# UNITED STATES PATENT AND TRADEMARK OFFICE

APPLICATION NO.	FILING DATE	FIRST NAMED INVENTOR	ATTORNEY DOCKET NO.	CONFIRMATION NO.
10/561,206	12/19/2005	Alan Howard Greenaway	WFS 034	3906
20/987 7590 08/01/2008 VOLENTINE & WHITT PLLC ONE FREEDOM SQUARE 11951 FREEDOM DRIVE SUITE 1260 RESTON, VA 20190				
EXAMINER TURNER, SAMUEL A				
ART UNIT		PAPER NUMBER		
2877				
MAIL DATE		DELIVERY MODE		
08/01/2008		PAPER

### Office Action Summary

## **DETAILED ACTION**

Figure 12

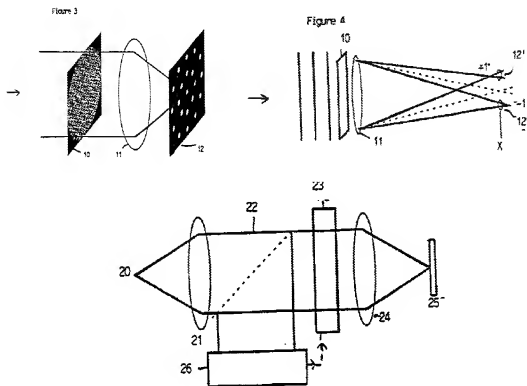
With regard to claim 1, Neil et al teach a measuring apparatus for determining data relating to the shape of an input radiation wavefront, the wavefront shape being describable at a pre-determined location in an optical system(Figs: 3, 4, 12), the apparatus comprising:

As to claim 4/1, Neil et al teach a wavefront modulator(Fig 12, 23; and page 13, lines 19-24).
